Project	<b>IEEE 802.16 Broadband Wireless Access Working Group</b> < <a href="http://ieee802.org/16">http://ieee802.org/16</a> >	
Title	<b>Correction of inconsistencies for 802.16-2004 OFDMA symbol clock frequency tolerance</b>	
Date Submitted	<b>2005-03-16</b>	
Source(s)	Juergen Otterbach Joerg Schaepperle Roland Muenzner Torsten Fahldieck Alcatel SEL AG	Voice: +49-711-821-32255 Fax: +49-711-821-32453 <a href="mailto:juergen.otterbach@alcatel.de">juergen.otterbach@alcatel.de</a>
Re:	Response to the call for comments IEEE 802.16-2004/Cor1-D1 Corrigendum to IEEE 802.16-2004	
Abstract	Correction of inconsistencies for 802.16-2004 OFDMA	
Purpose	Resolving ambiguity in OFDMA PHY layer §8.4	
Notice	This document has been prepared to assist IEEE 802.16. It is offered as a basis for discussion and is not binding on the contributing individual(s) or organization(s). The material in this document is subject to change in form and content after further study. The contributor(s) reserve(s) the right to add, amend or withdraw material contained herein.

# Correction of inconsistencies for 802.16-2004 OFDMA symbol clock frequency tolerance

Figure 2: Signal-to-interference ratio (SIR) as a function of the absolute tolerance of the sampling clock  $F_s$  in percent of the subcarrier spacing  $\Delta f$

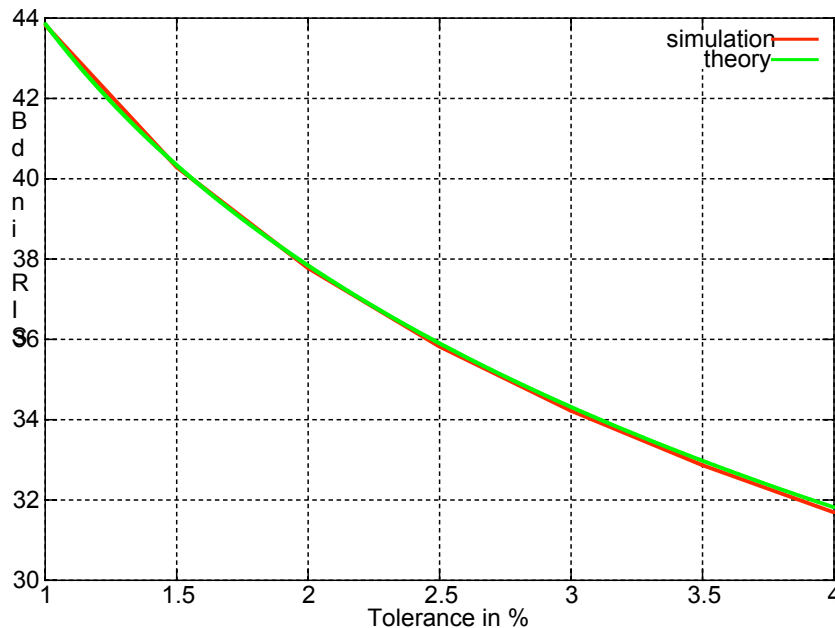
As an indication Figure 2 shows the resulting SIR values in function of the tolerance for the sampling clock frequency for a range of values, that still would leave some margin to the SNR requirement of 24.4 dB for 64 QAM.

A symbol clock frequency tolerance of 2 % of the subcarrier spacing on the other hand, as currently required in 802.16-REVd/D5, results due to the above relation between the symbol clock and the sampling clock frequency in a much higher tolerance for the sampling clock frequency. Therefore this requirement on the symbol clock frequency is not sufficient.

Even though a tolerance of the symbol clock frequency accuracy derived from the range of values for the sampling clock frequency shown in Figure 2 could be sufficient, there is a more direct means to guarantee a still higher accuracy exploiting the requirement that the symbol clock frequency and the center frequency are derived from a single reference at the BS and thus have a fixed and predefined ratio within the system.

The above inconsistencies could be solved and a sufficient accuracy for the symbol clock frequency at the SS could be achieved by explicitly stating that the accuracy of the symbol clock frequency at the SS is guaranteed by its locking to center frequency at the SS, thereby exploiting the fact that through the requirement, that the symbol clock frequency and the center frequency are derived from a single reference at the BS, they have a fixed and predefined ratio.

At the SS, the transmitted center frequency ~~and the symbol clock frequency~~ shall be synchronized to the BS with a tolerance of maximum 2% of the subcarrier spacing and the sampling frequency of the SS shall be synchronized to the sampling frequency of the BS with a tolerance of maximum  $0.02 \times$  (subcarrier spacing).
